# ATTACHMENT 10

## PLAN REVIEW COMMENTS FOR COFA-04-23-017894

Architect's response and supporting materials

1 ELEVATION OF RECONSTRUCTED SHUTTERS (FRONT)  
SCALE: 1 1/2" = 1'-0"

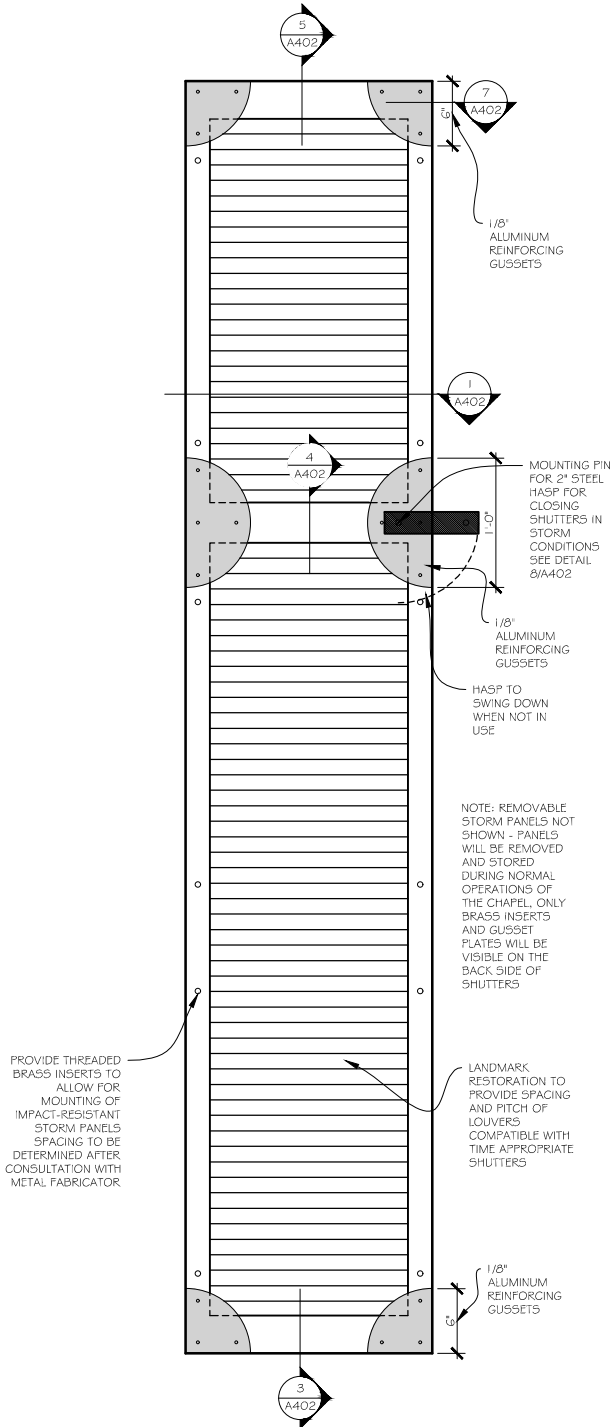
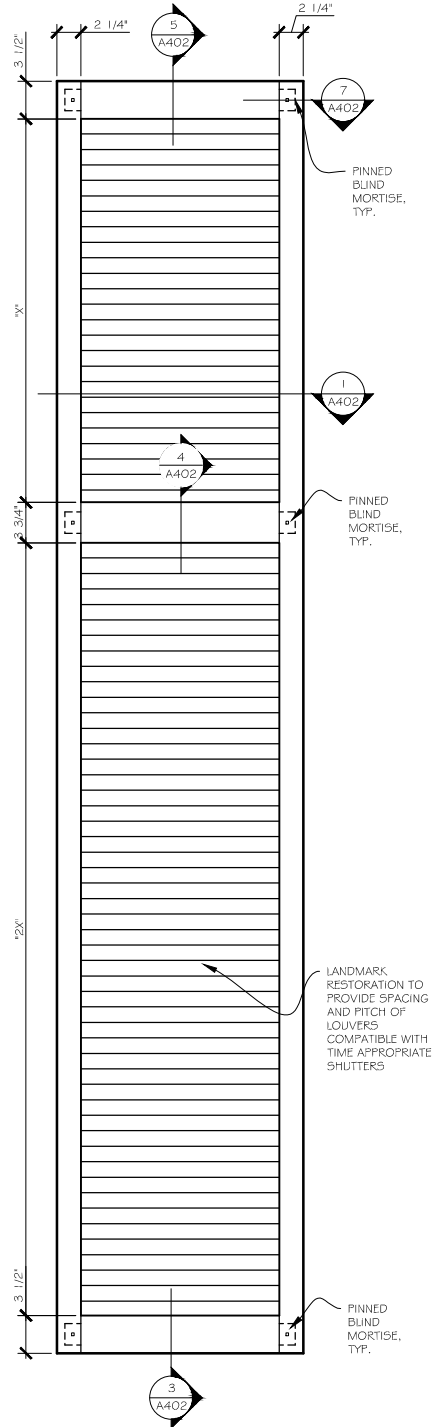
- Growth Management Dept Review (Glen Umberger)
  - 3.18.3 Comment 1: "...additional historic research will be required to document the existence of shutters and associated hardware before fabrication and installation of new shutters will be permitted."

- The following note has been added to the restoration set of drawings: "Note: additional on-site research and historic research will be performed prior to any fabrication to determine when and if shutters would have been present in 1874. Hardware style and attachment will be researched. Should evidence indicate shutters were not present in 1874, shutters will not be installed"

NOTE: SHUTTER HARDWARE TO BE DETERMINED FOLLOWING FURTHER RESEARCH AND INVESTIGATION OF ARCHEOLOGICAL EVIDENCE

NOTE: SHUTTER HARDWARE TO BE DETERMINED FOLLOWING FURTHER RESEARCH AND INVESTIGATION OF ARCHEOLOGICAL EVIDENCE

1 FRONT (WEST) ELEVATION

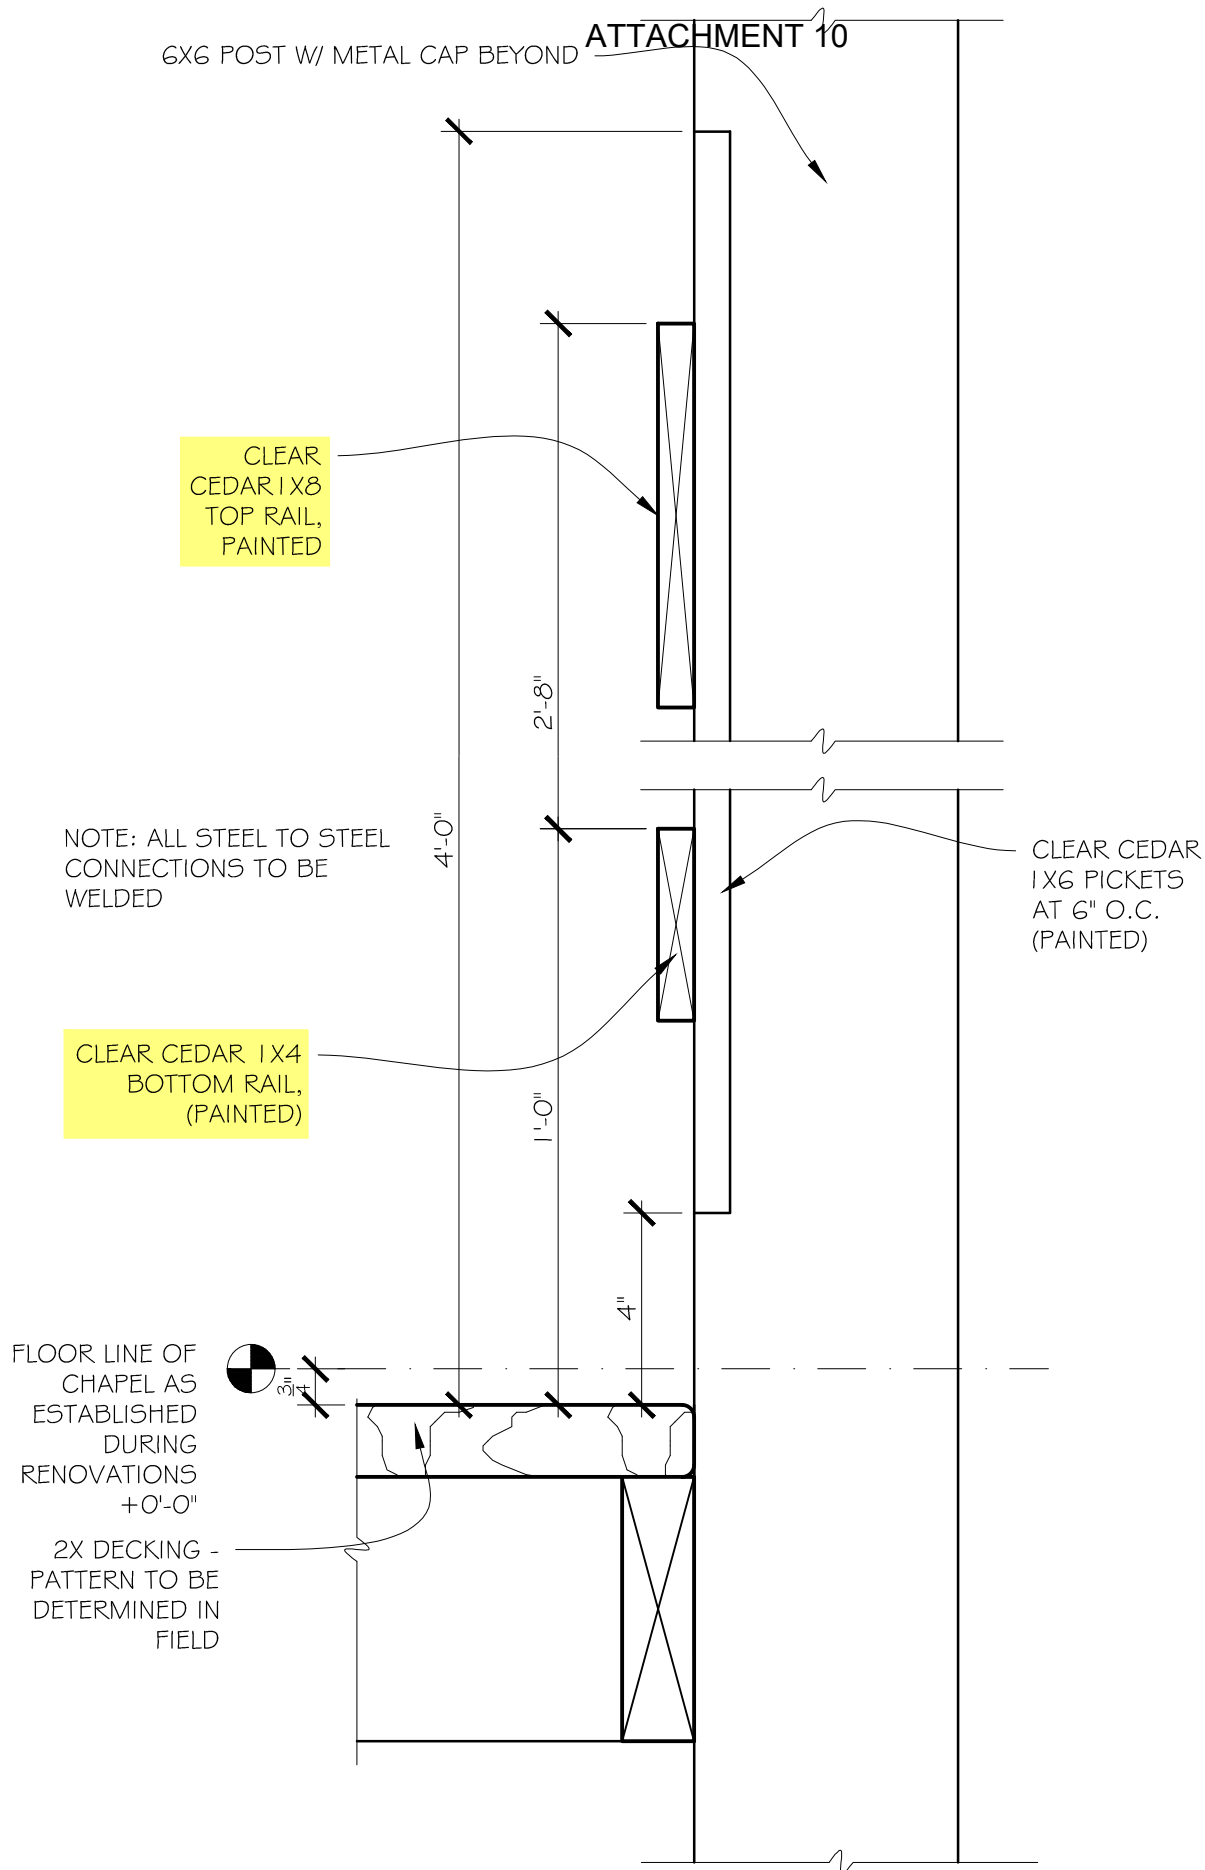
- 1/A202 – shown in full set
    - 2/A202 – shown in full set
  - 3.18.3 Comment 3: "...additional documentation will be required for the existence of a metal cross/finial on top of the belfry before this architectural feature is permitted"

- 2/A402 – attached as 8.5x11 – See Page 9
- Article 5 Comment 2: "...Provide additional information on proposed exterior wood doors for front and rear elevations of historic resource..."

- Drawings have been noted to specify a painted wooden cross/finial
    - 1/A201 – attached as 8.5x11 – See Page 7
    - 1/A202 – shown in full set
    - 2/A202 – shown in full set

- Existing front doors to remain; rear doors have been removed and will be cased openings
  - 1/A201 – attached as 8.5x11 – See Page 7
- Article 5 Comment 3: "...Provide additional information for the proposed replacement windows in the historic resource and new windows in the proposed addition..."

NEW PAINTED  
WOOD CROSS  
FINIAL

EXISTING DOORS TO REMAIN

TYPICAL WOOD GUARDRAIL SECTION

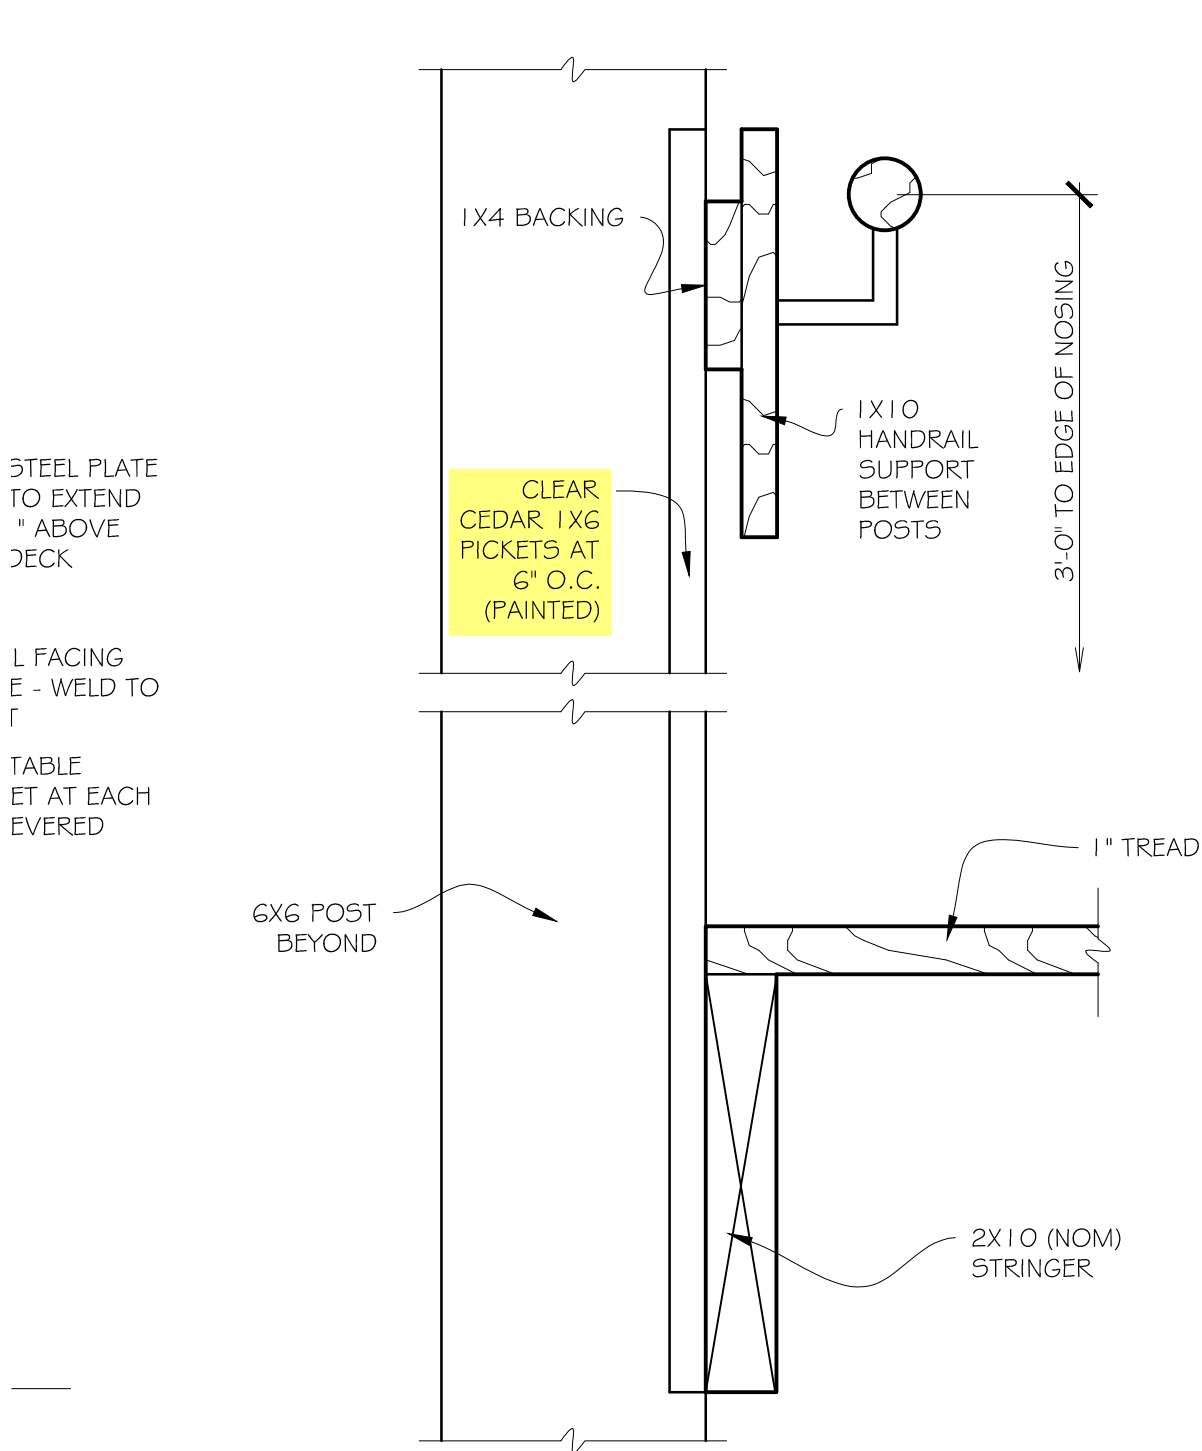
- See Article 5 Comment 4 below
- Article 5 Comment 1: "... provide additional information on railing details as not enough information has been provided to ensure compliance with material and configuration"

- All wood portions of railings to be painted clear cedar
  - All metal portions of railings to be painted steel
  - See supplementary detail – attached as 8.5x11 – See Page 8

2 REAR (EAST) ELEVATION  
SCALE: 1/4" = 1'-0"

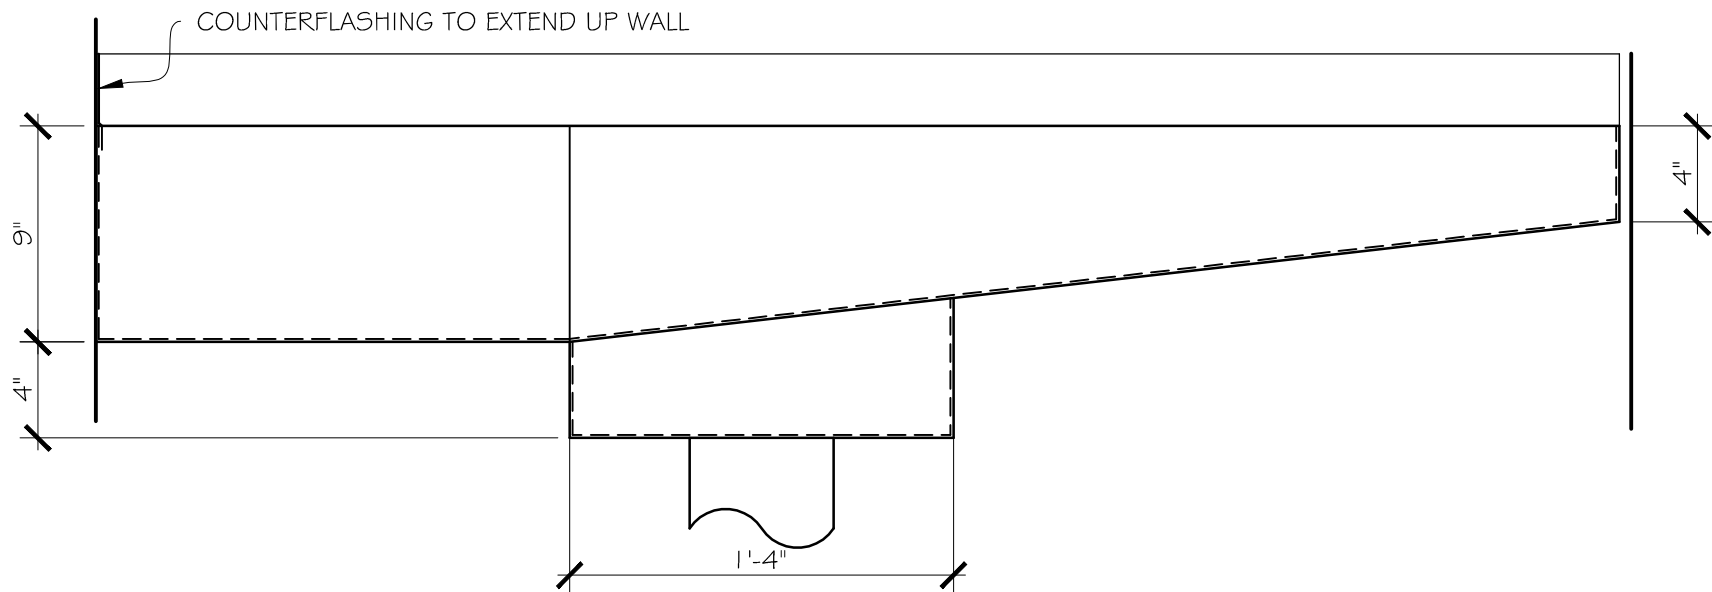
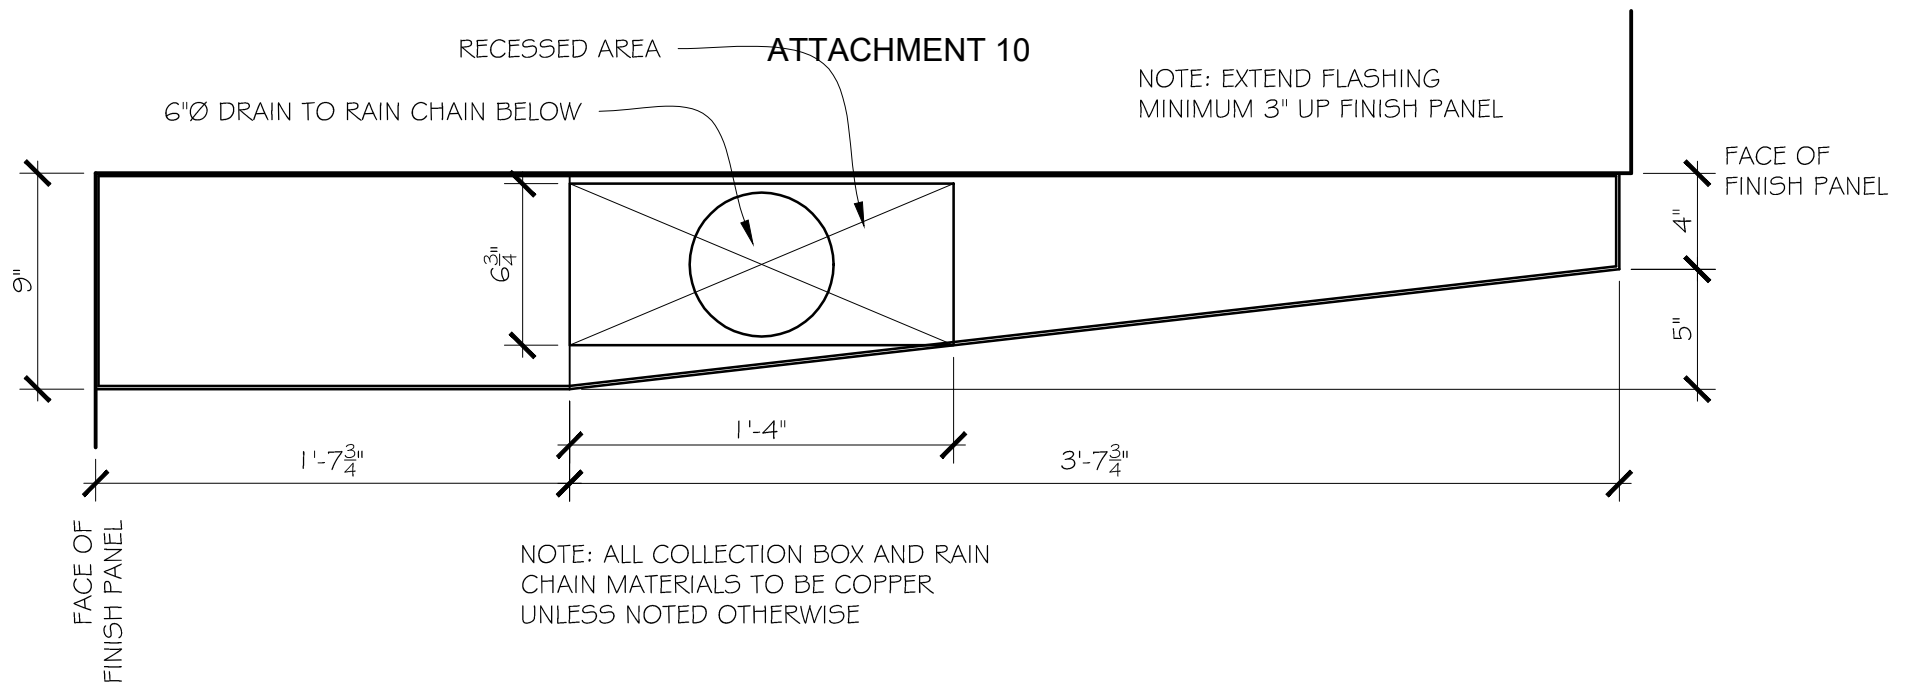
- Sash Detail – attached as 8.5x11 – See Page 10
- Article 5 Comment 4: "...wood shingles which are not a permitted material...nor is a fully adhered membrane roof..."

- 1/A302 – attached as 8.5x11 – See Page 17
    - 7/A401 – attached as 8.5x11 – See Page 18
    - 1/A403 – attached as 8.5x11 – See Page 19
  - Comment 3: “Provide additional information regarding the intent of the parapet and flat roof for the connection”

- The following note has been added to all drawings and details showing a parapet: "The employment of a membrane roof requires the use of a parapet to conceal from eye-level view the membrane, flashing, and vents, and to redirect water towards collection box, thus eliminating the visual clutter of gutters and downspouts on the addition"

THE EMPLOYMENT OF A  
MEMBRANE ROOF REQUIRES THE  
USE OF A PARAPET TO CONCEAL  
FROM EYE-LEVEL VIEW THE  
MEMBRANE, FLASHING, AND  
VENTS, AND TO REDIRECT WATER  
TOWARDS COLLECTION BOX,  
THUS ELIMINATING THE VISUAL  
CLUTTER OF GUTTERS AND  
DOWNSPOUTS ON THE ADDITION

COLLECTION BOX PLAN AND ELEVATION

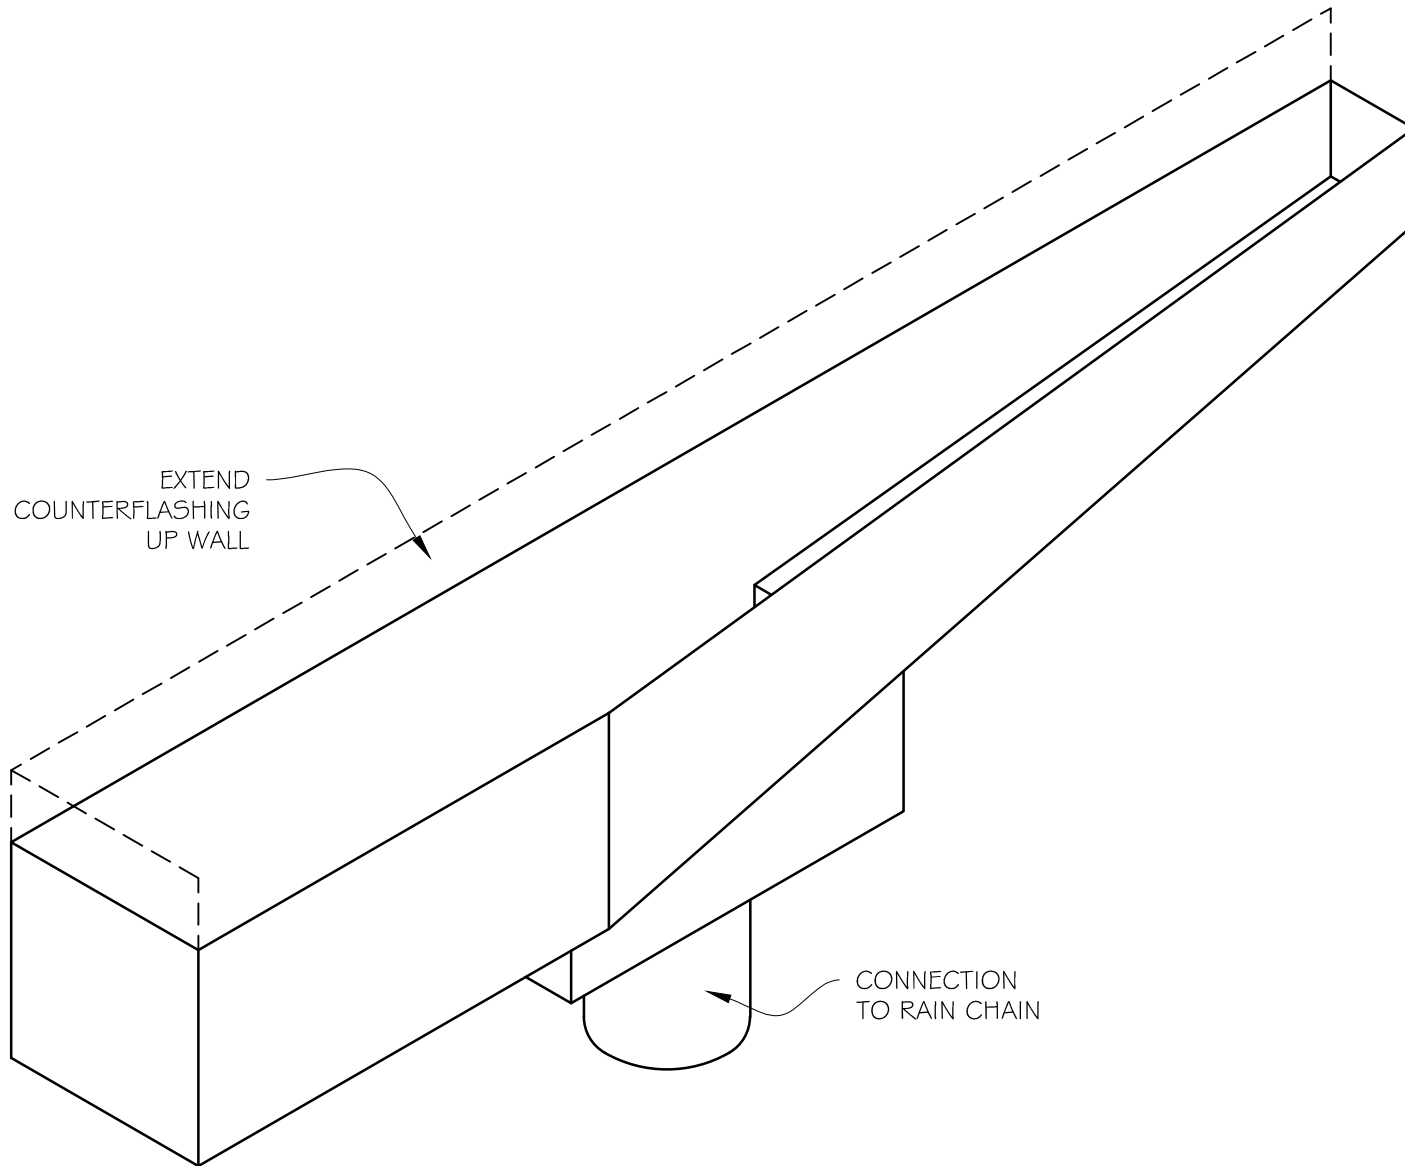
- 1/A304 – shown in full set
  - 5/A401 – shown in full set
- Article 5 Comment 5: "Provide additional information on gutters and rain chains (downspouts)..."

- See supplementary details of collection box and rain chain – attached as 8.5x11 – See Pages 12 and 13
